HIDEOUT, UTAH
CONTINUED PUBLIC HEARING –
SHORELINE PHASE 2A AMENDED AND PHASE 3
June 02, 2021
Agenda

Staff Review for Town Council

Re: Shoreline Phase 3 (and Amended Phase 2)

RE: Shoreline Phase 3 Final Review

Figure 1: Phase 3 Proposed Road Cross Section

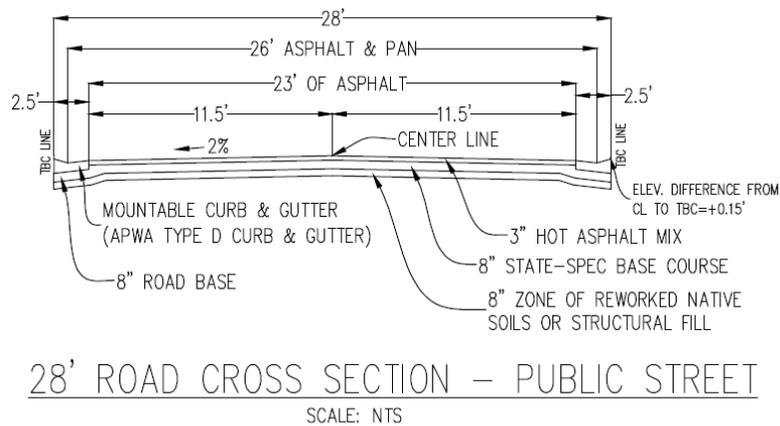
- a. Asphalt roadway width must be 26 feet (plus curb and gutter) per the Wasatch County Fire Marshal (attached). These changes must be shown on the new plan set.

The proposed roadway cross-section, as shown in **Figure 1** is 28 feet, meets both the vested code requirements as well as the recently adopted 2020 Code requirements for a neighborhood road (although travel lanes and shoulders are sized differently) and exceeds the State adopted fire code by 2' (discussed further later in the memo).

26' ROAD CROSS SECTION

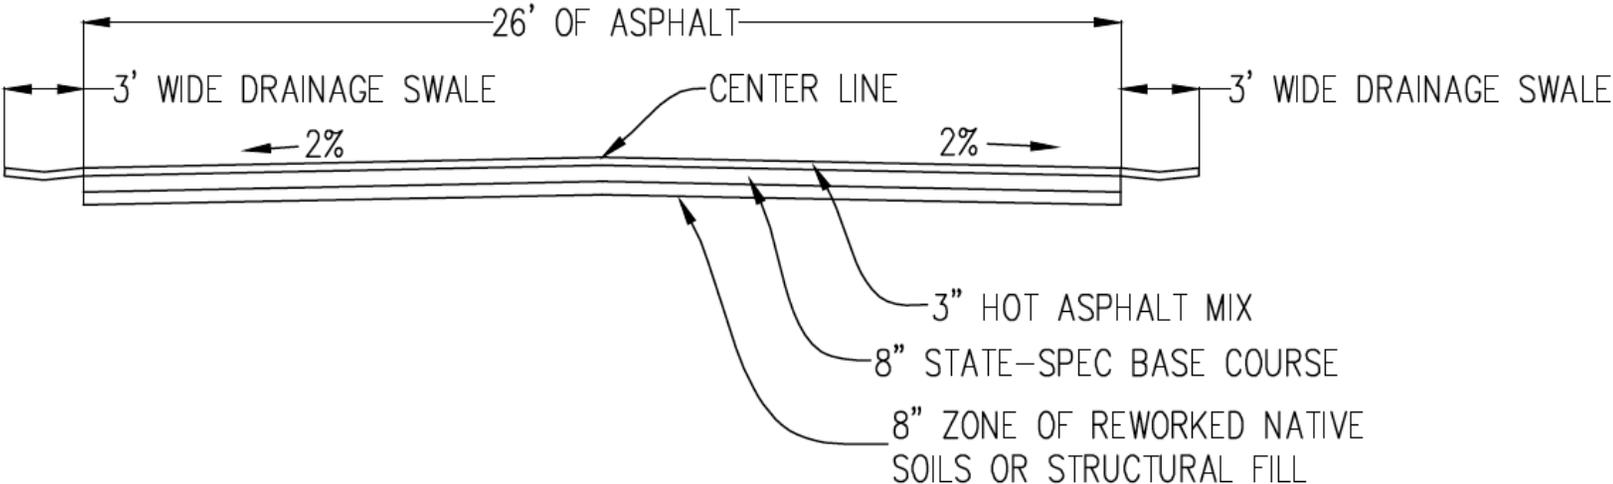
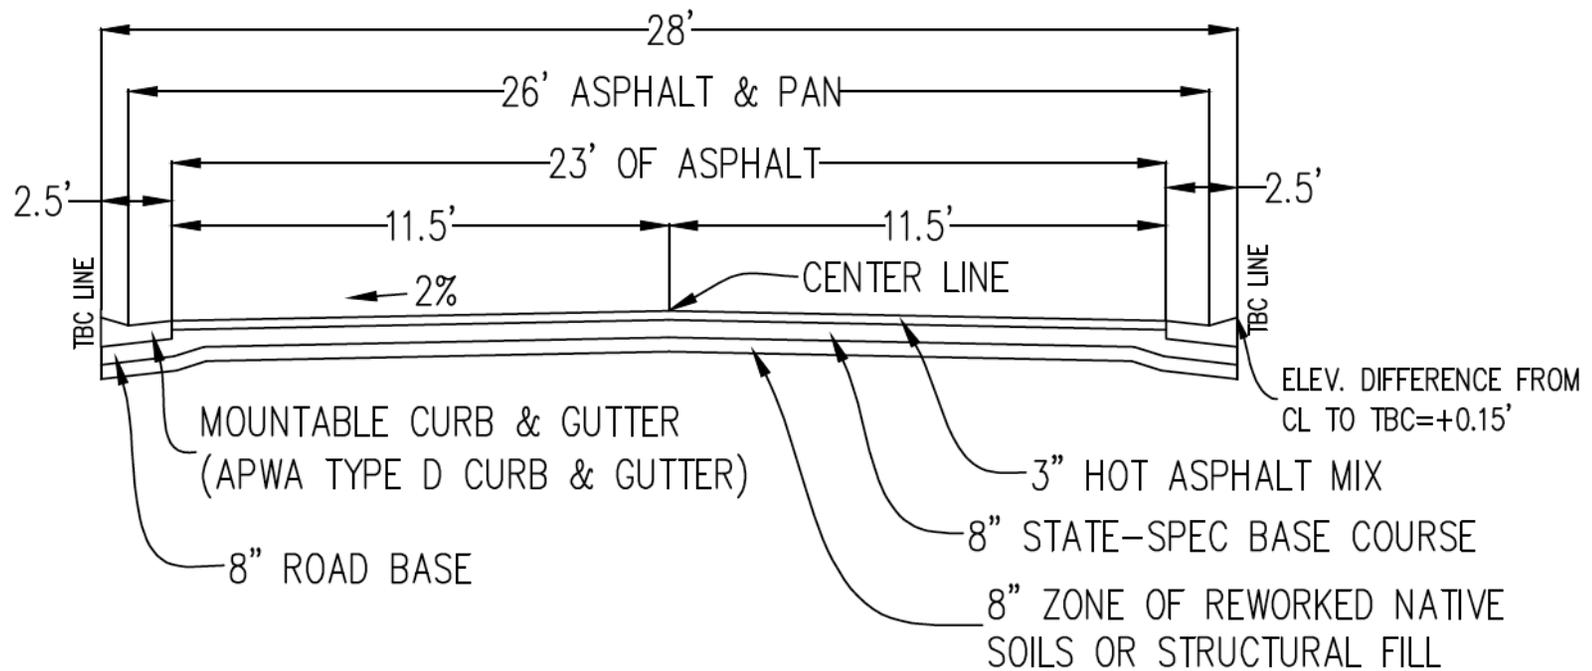
The Town Code, with the recommendation of the Wasatch County Fire District, requires 26'-0" of asphalt plus curb and gutter. The Applicant is proposing a narrower road.

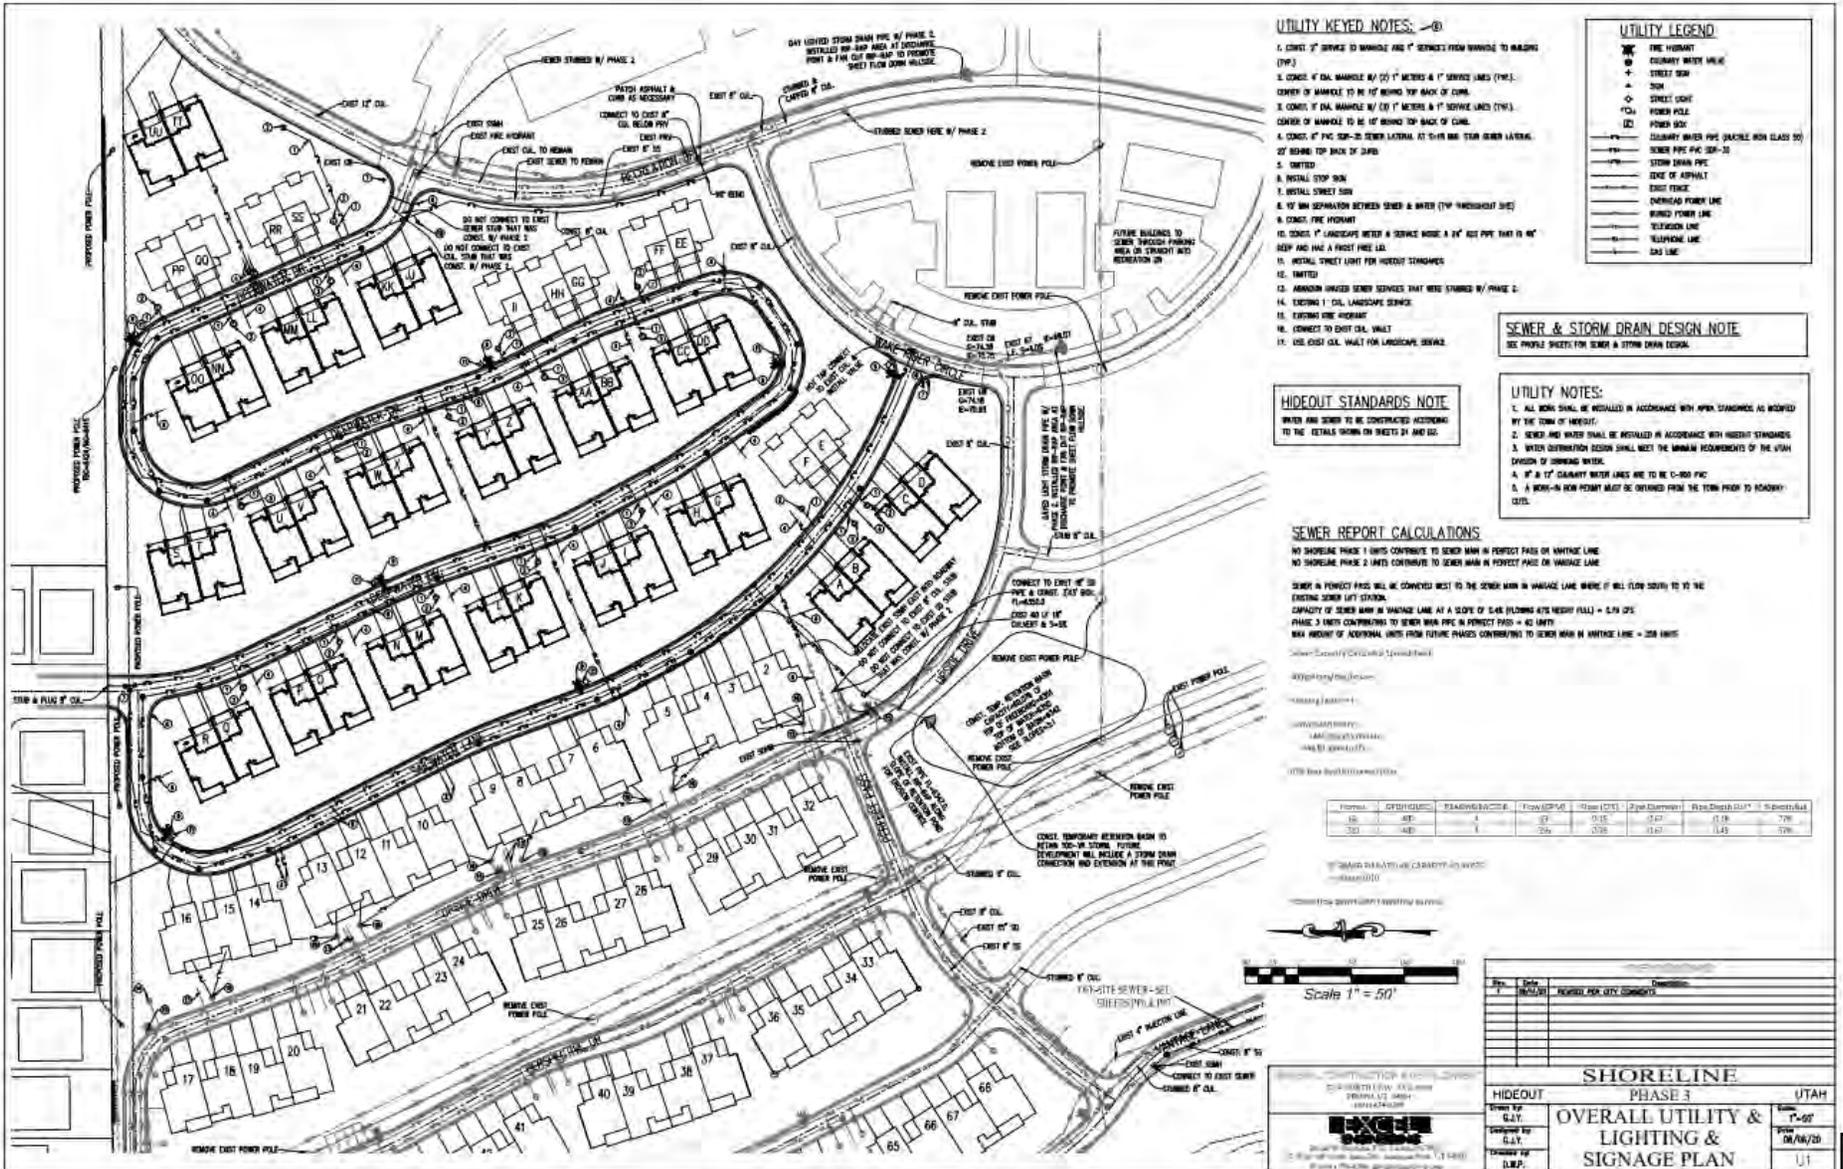
Wasatch Fire has completed the initial review of Shoreline Phase 3 with the following comments.

- Secondary access is still needed for Shoreline Phase 2A as a condition of the final approval granted on March 8, 2019. The provided access connection on Wake Rider Circle is still only a single point access. As per the approval letter for 2A, permanent secondary access is required prior to any further approvals.
- Roads must be a minimum of 26-foot unobstructed width for their entirety. Parking must be regulated to approved locations and not obstruct apparatus access roads.

Wasatch Fire cannot approve the plans as submitted due to the single point of access for Shoreline 2A and the proposed Phase 3 due to the single point of permanent access onto Recreation Drive. All roads (Deepwater Drive, Sailwater Drive and Upside Drive) have a single connection point on Recreation Drive. Any emergency at or near Recreation Drive would render it unusable and impede evacuations.

Also of concern is the winding road of Deepwater Drive, how are these homes to be addressed. It appears that the potential for a delayed response due to the closeness / similarity of addresses is problematic.
